QUEENS HALL – WORKS IN AND AROUND THE WAR MEMORIAL

1.0 EXECUTIVE SUMMARY

- 1.1. The purpose of this report is to seek member's views on a previously received request from the local branch of Legion Scotland to vary the design and scope of works associated with the public realm works as they affect the towns War Memorial located on the Pier Esplanade.

Appendix 1: Comments from Dunoon Branch, Legion Scotland

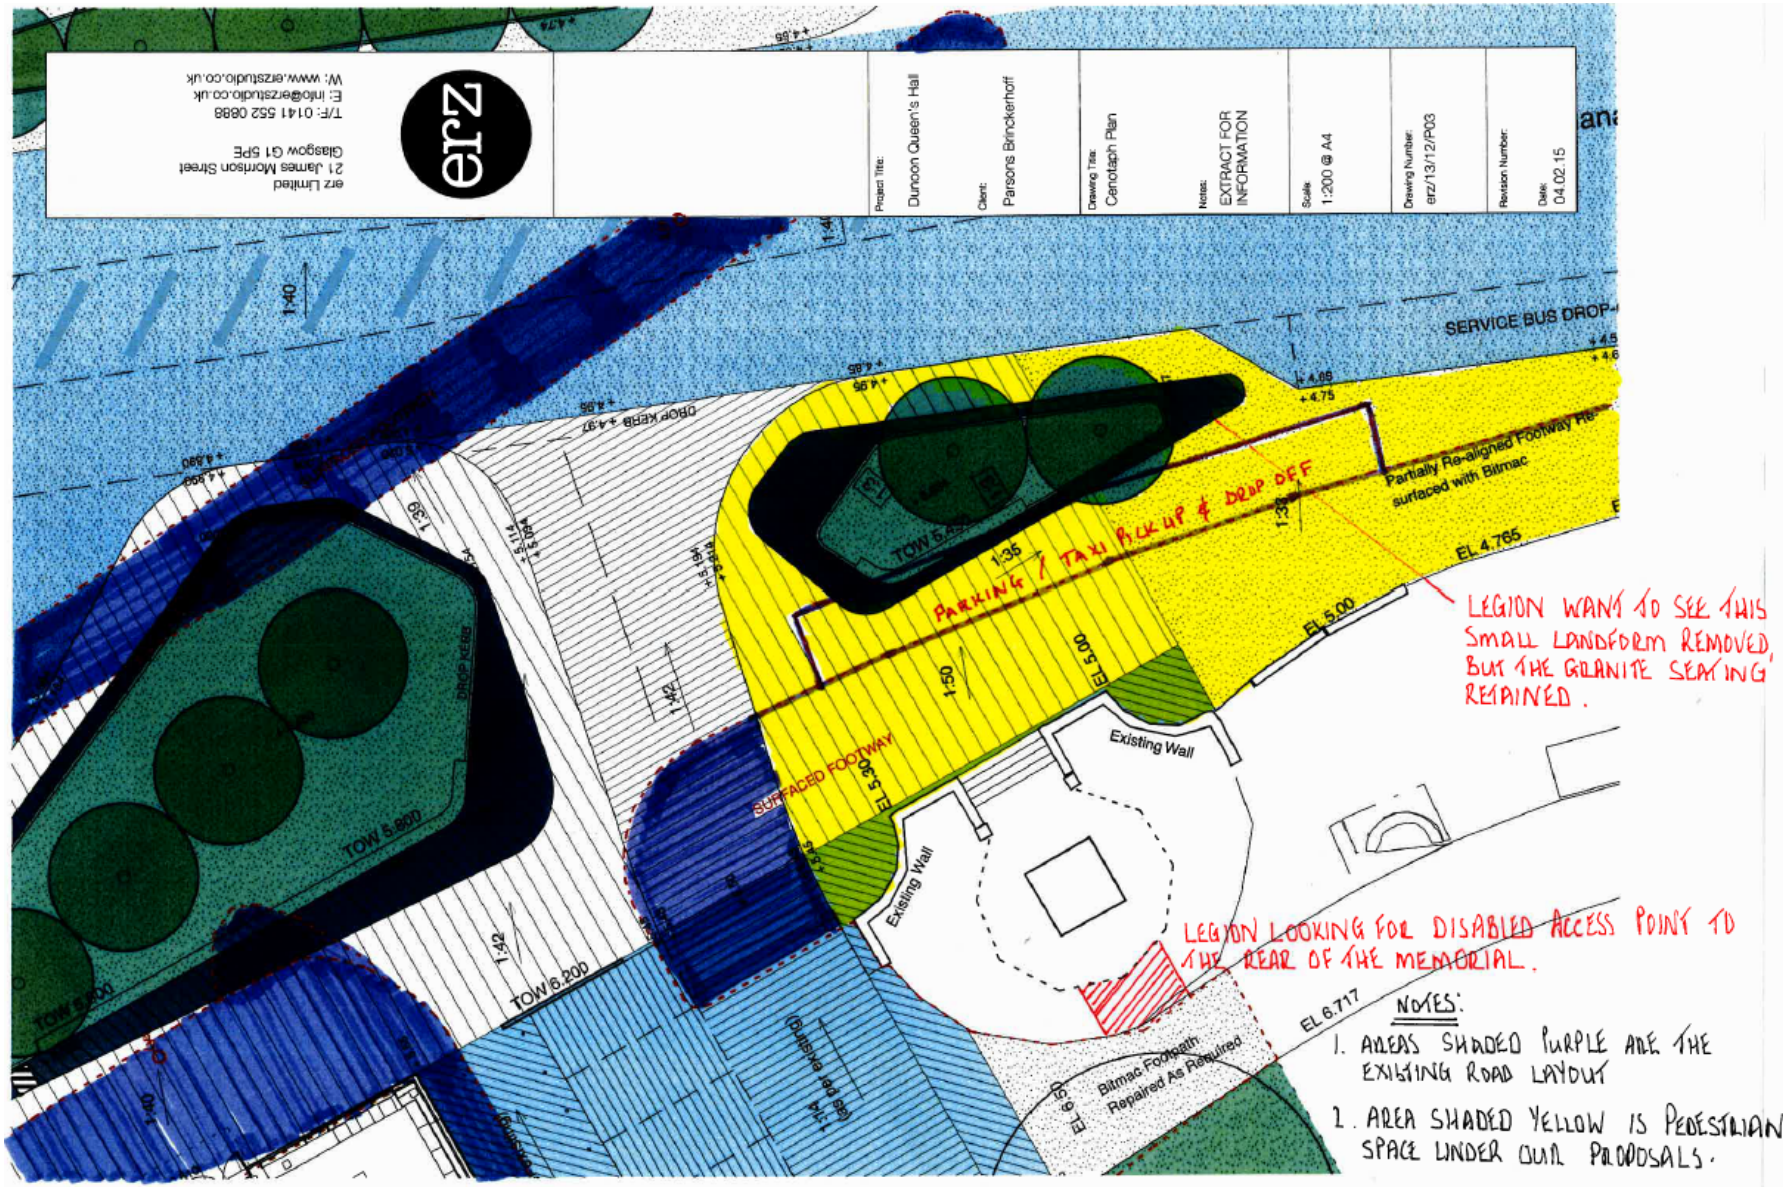
- 4.1 On 2 March 2015 the Regeneration Project Manager (**RPM**) was invited to give a presentation on the Queens Hall project to the Dunoon Branch of Legion Scotland, with their particular interest being in the impact of our proposals on the War Memorial.
- 4.2. At the presentation the Legion raised the following points of concern (refer to sketch at **Appendix 1**):
 - 4.2.1. The small landform which is planned to the front of the Memorial will restrict the numbers wishing to take part in remembrance and memorial services/parades. This is especially important just now as we are at the Anniversary of WW1 and a number of public bodies and Clubs wish more than ever to attend and pay their respects. As the plan shows at the moment 100 square meters is simply not enough it is thought.

4.2.2. At the moment there is no disabled access to the memorial. There could be an opportunity to allow access for wheelchair users to pay their respects from an access point to the rear of the garden.

4.2.3. Lastly there are no plans to touch the memorial at all within this project which concerns the Legion as they consider that the monument, could do with re pointing and cleaning.

4.3.1. We are keen to highlight some comments in relation to your discussions around the war memorial / cenotaph area. We understand omission of the small landform opposite the cenotaph was discussed, as a means of creating more space for memorial events.

- We would strongly suggest the small landform is kept, noting the following points:
- The current proposals including landform, provide an increased public space in front of the memorial when compared with existing (6.5m proposed; 4.5m existing). For clarity, 6.5m is wider than a standard road carriageway for two lanes of traffic.

- The landform creates a sheltered space in front of the memorial, shielding it from the adjacent roadway, providing a more dignified space for contemplation.

- The small landform is part of the scheme that has planning approval; through this there was presumably the opportunity for the group to have commented in advance of detailed design.

- In cost terms, I would suspect there would be no saving here, if anything it is likely to be a cost uplift in moving from grass to granite surface.
- In summary, we are respectful of the views of the memorial group, but we are concerned that they have not interpreted our proposals fully. We feel the small

Appendix 2: Option 1 – Contracted Works

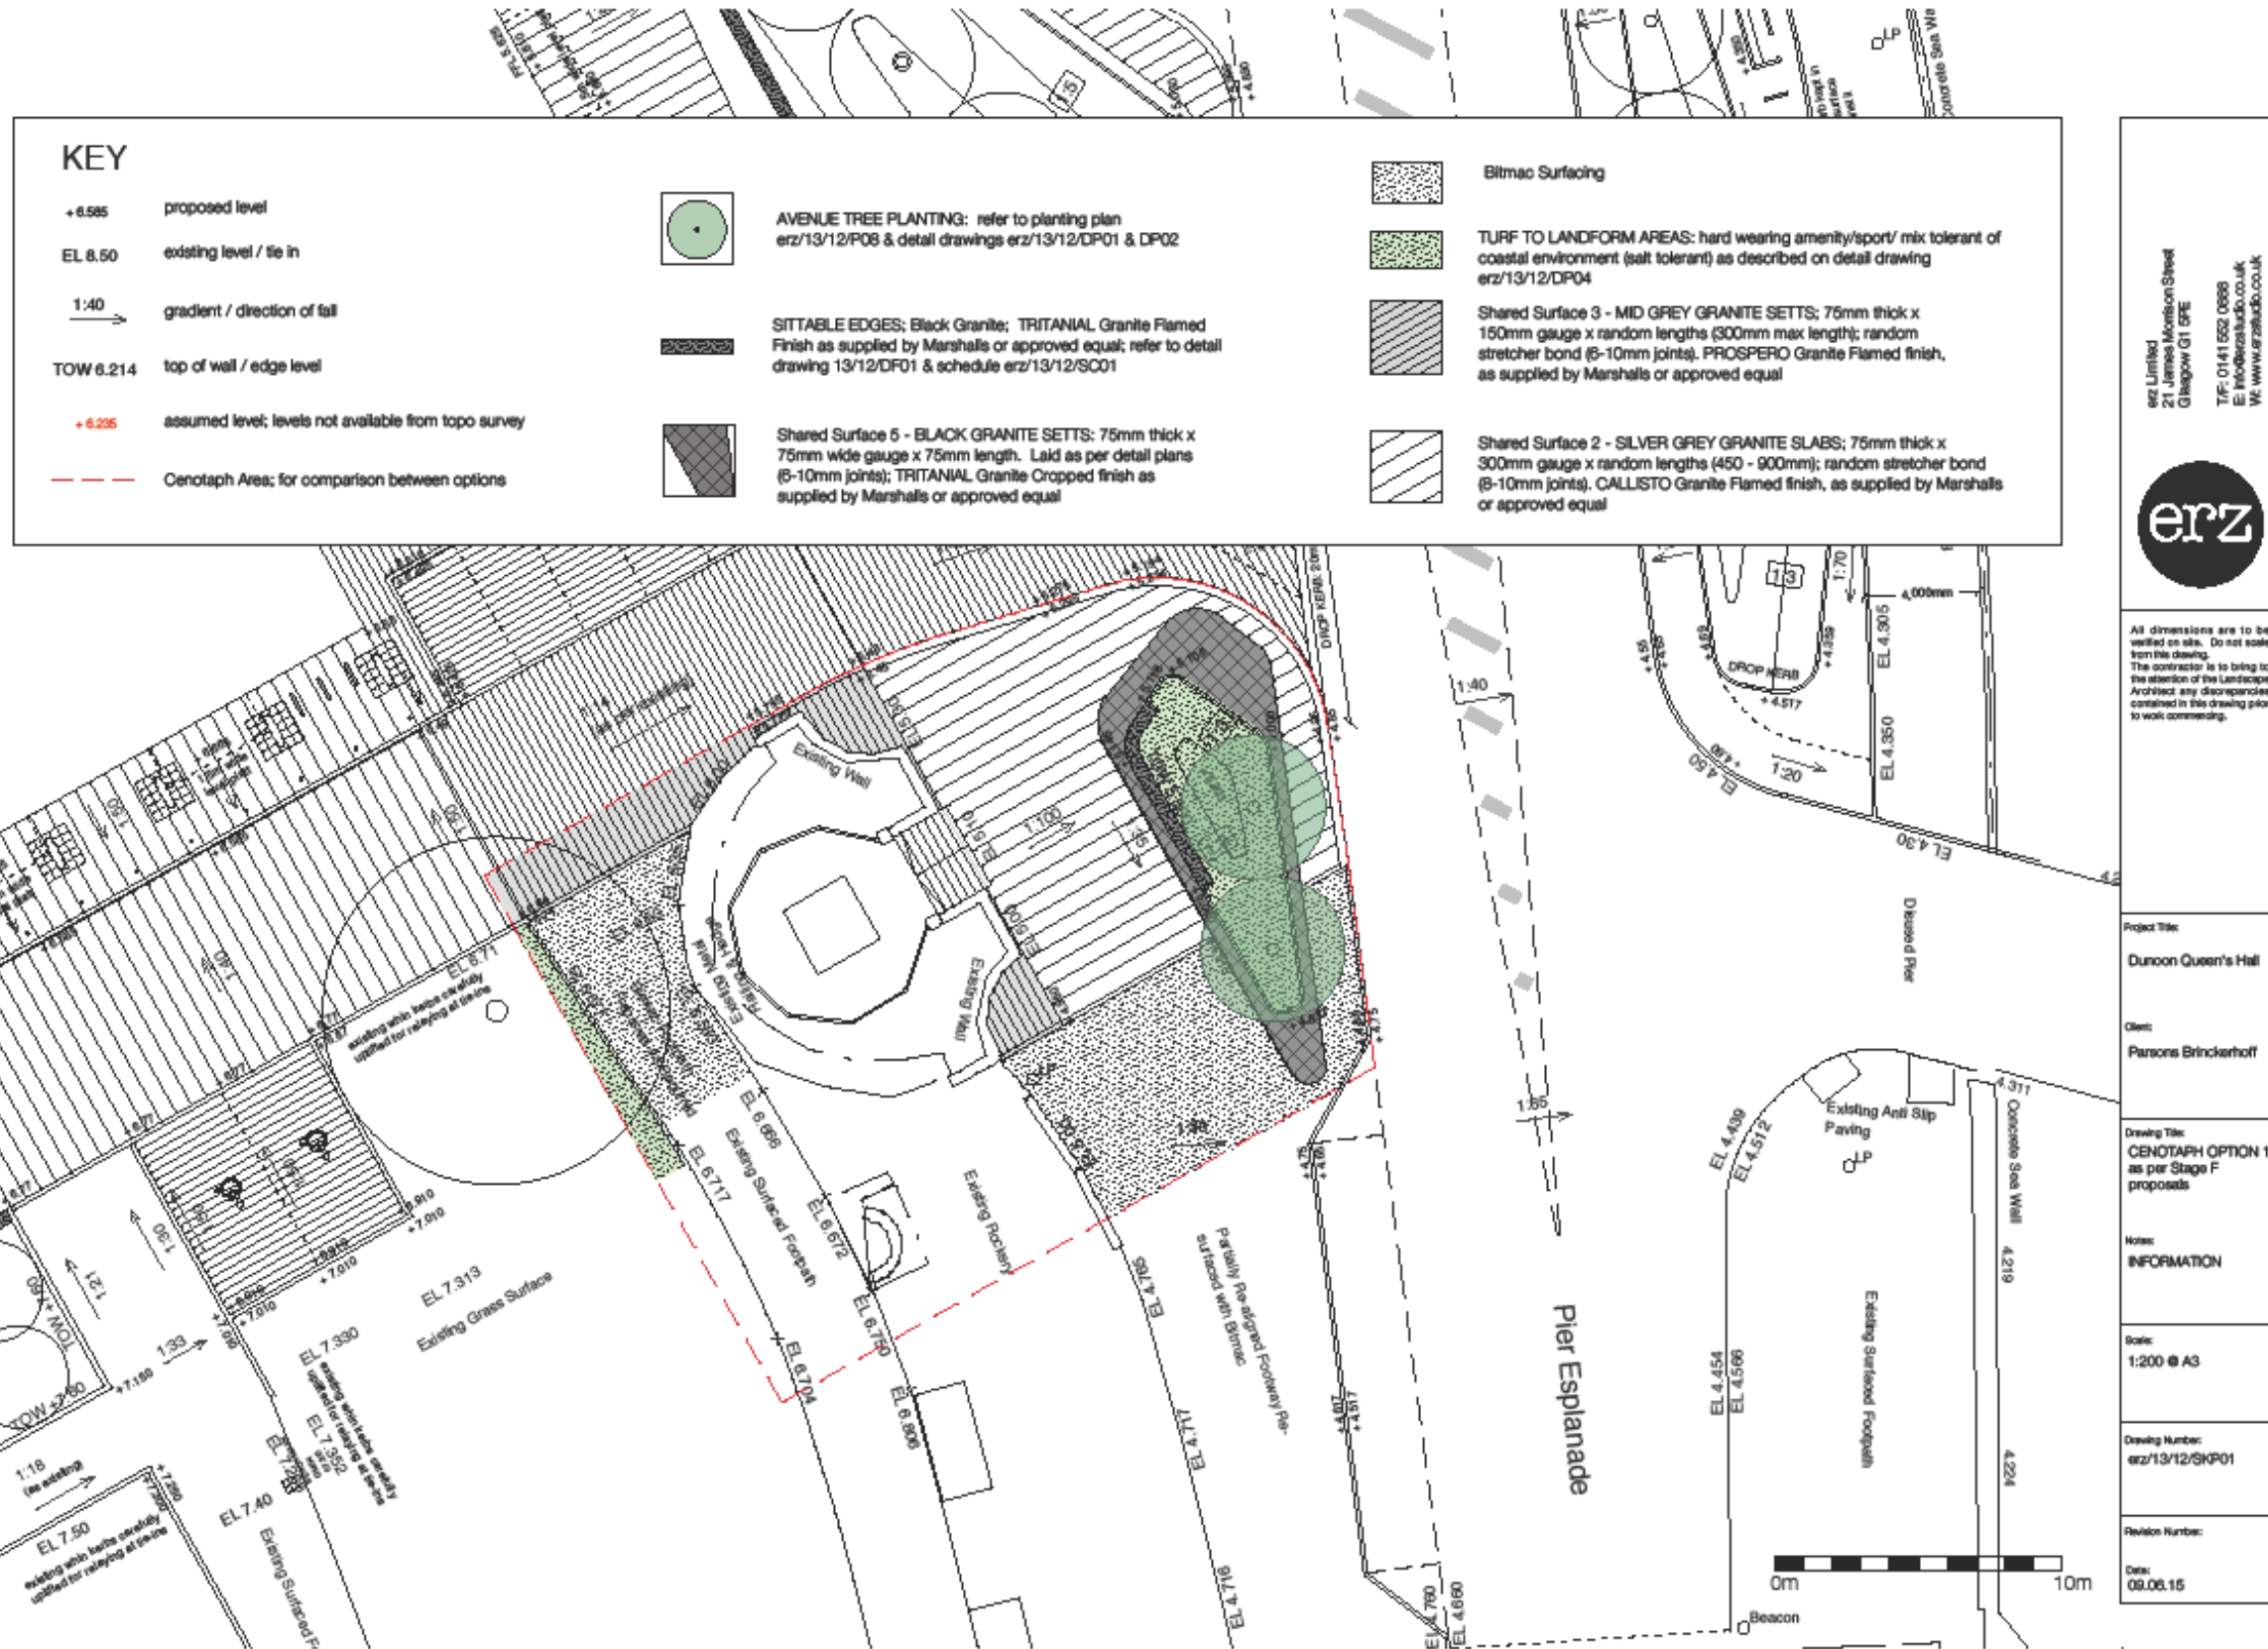
- **Option 1 – THE CONTRACTED WORKS** – Design as included in the tender documentation and which currently forms part of the works as contracted with McLaughlin & Harvey Ltd.
- **Option 2 – THE VARIATION WORKS** – This option would see the removal of the small grassed landform to be replaced with black granite setts. Disabled access would be provided to the rear of the war memorial using new levels to give a 1:12 ramp which would comply with the DDA requirements.

Appendix 3: Option 2 – The Variation Works

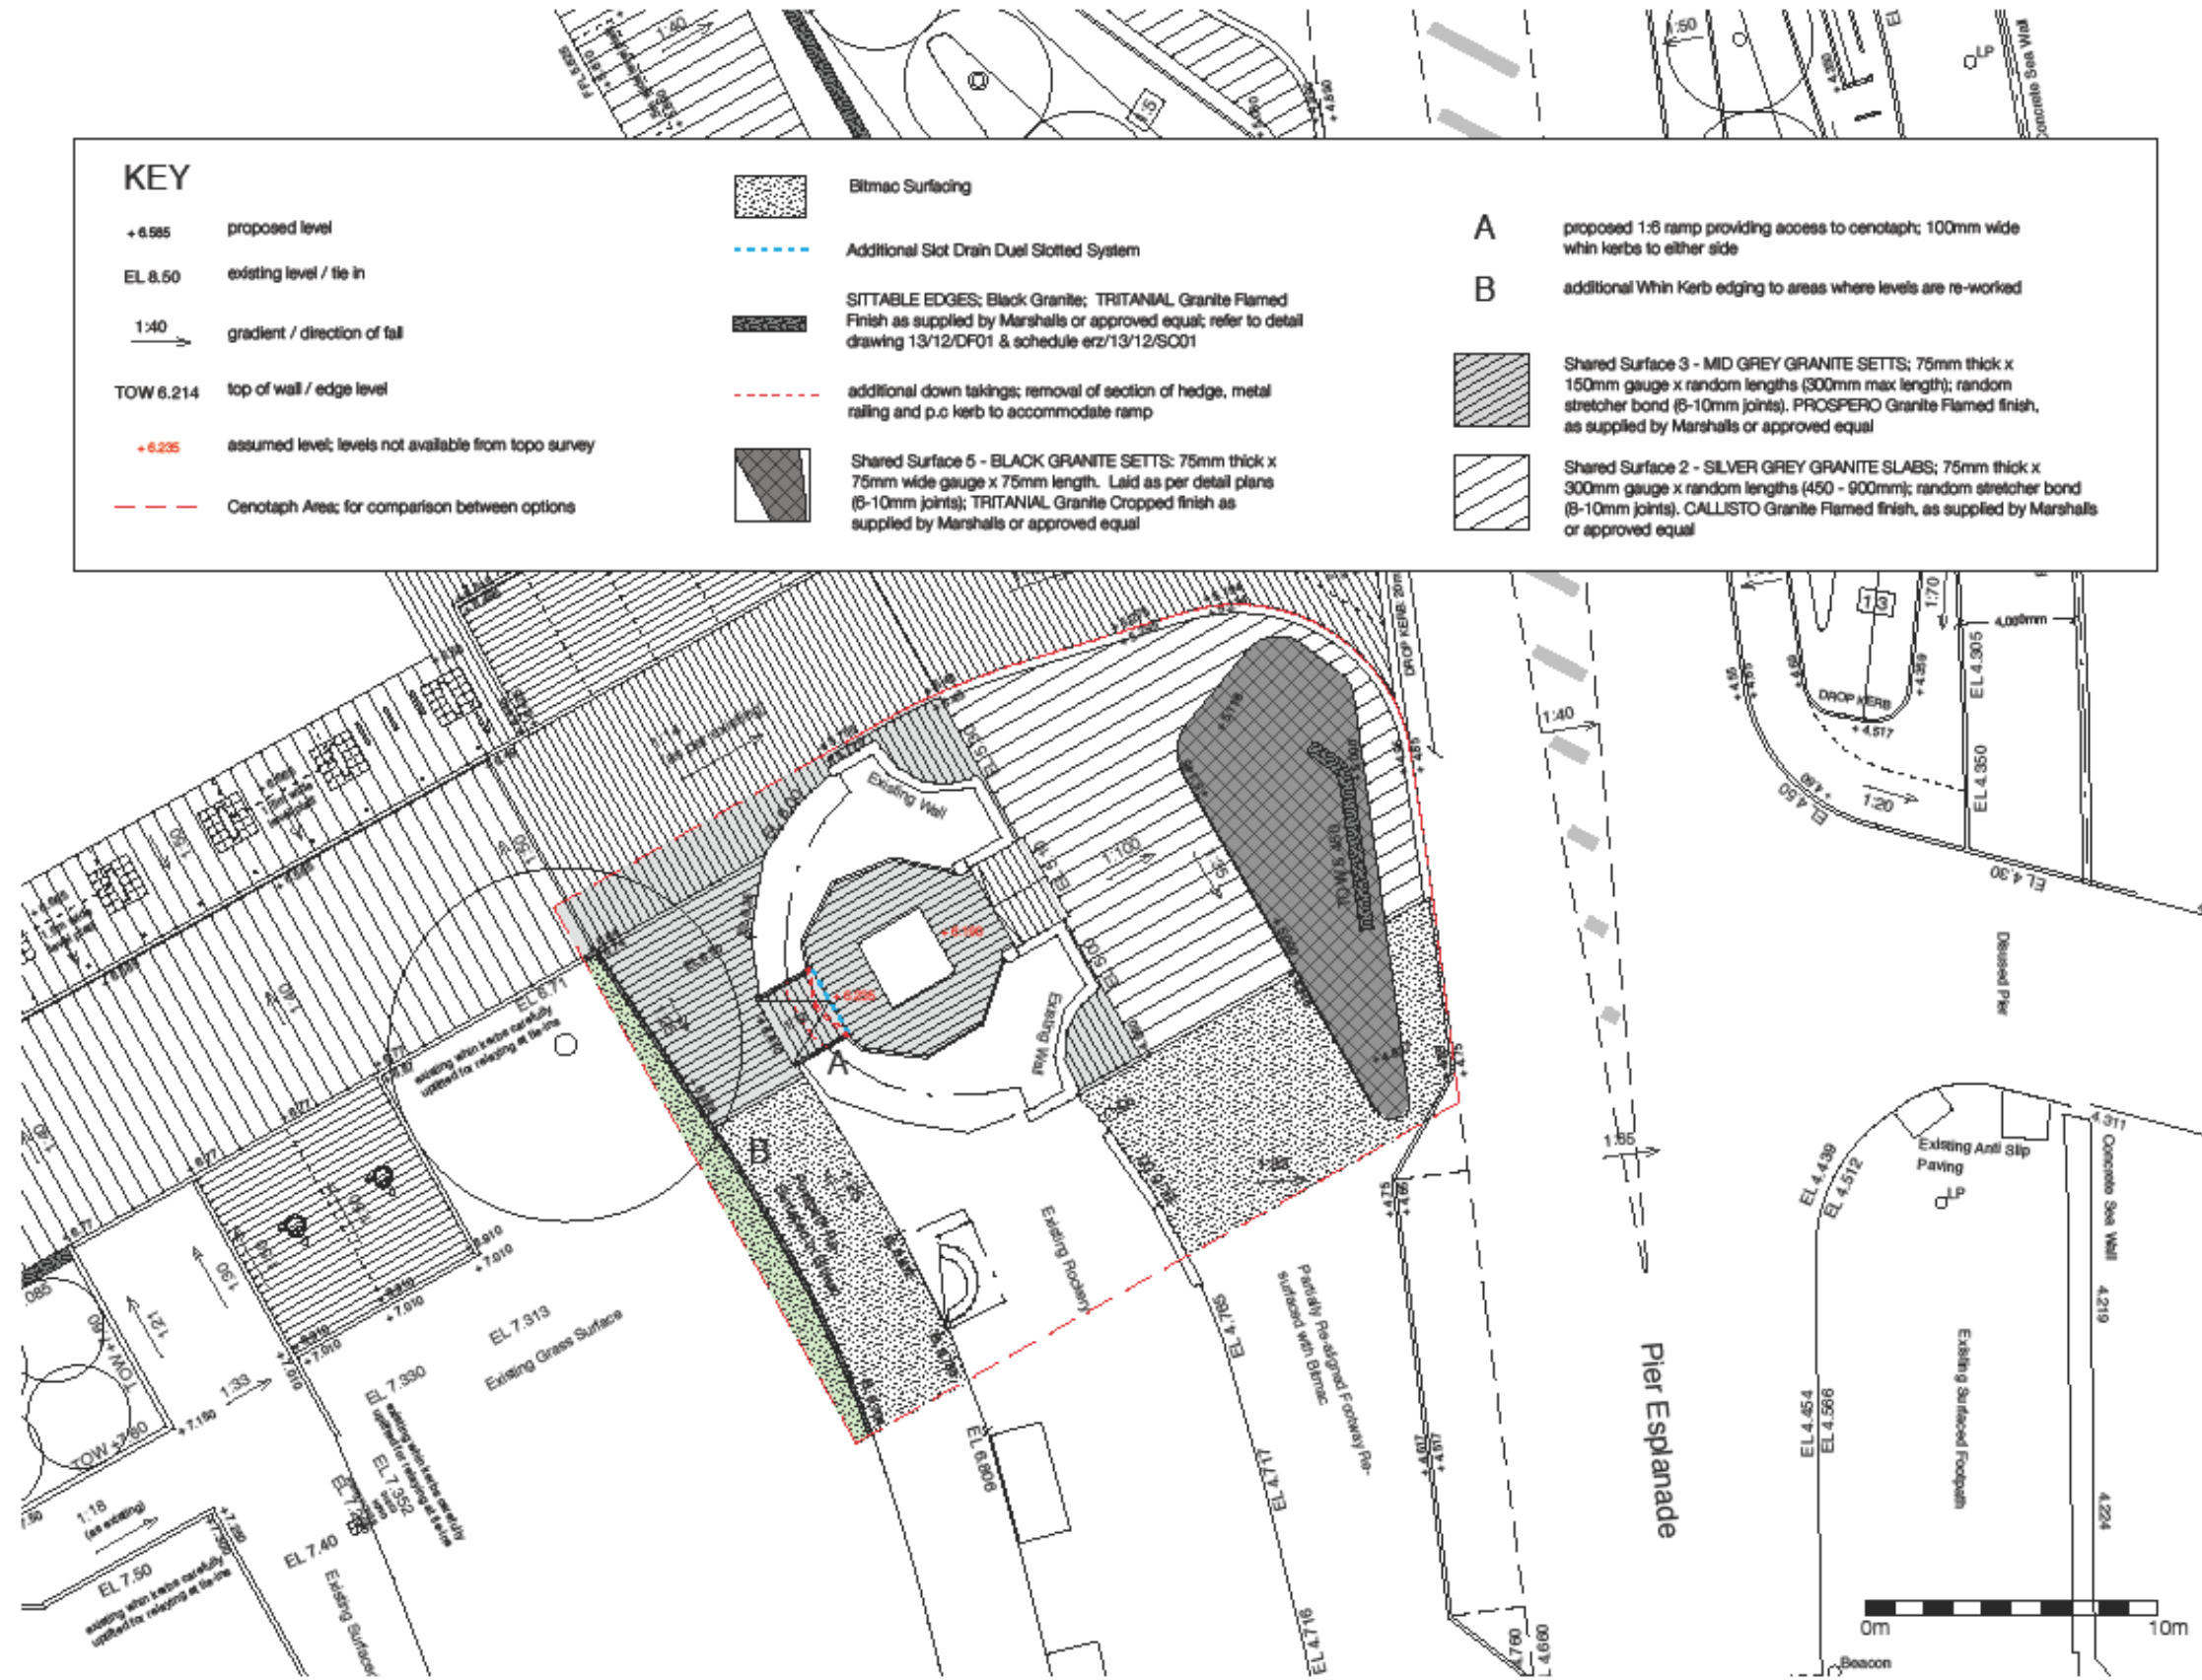
- 4.5. The Contract Price includes a Provisional Sum allowance of £10,500 for additional works to the War Memorial based on the design solution for Option 2 – The Variation Works. McLaughlin and Harvey have provided costs for Option 2 – the Variation Works at £12,738.73 i.e. £2,238.73 over the provisional sum allowance, however this could be managed within the overall approved budget for the project.

- A** proposed 1:5 ramp providing access to cenotaph; 100mm wide whin kerbs to either side
- B** additional Whin Kerb edging to areas where levels are re-worked
- Shared Surface 3 - MID GREY GRANITE SETTS; 75mm thick x 150mm gauge x random lengths (300mm max length); random stretcher bond (8-10mm joints). PROSPERO Granite Flamed finish, as supplied by Marshalls or approved equal
- Shared Surface 2 - SILVER GREY GRANITE SLABS; 75mm thick x 300mm gauge x random lengths (450 - 900mm); random stretcher bond (8-10mm joints). CALLISTO Granite Flamed finish, as supplied by Marshalls or approved equal
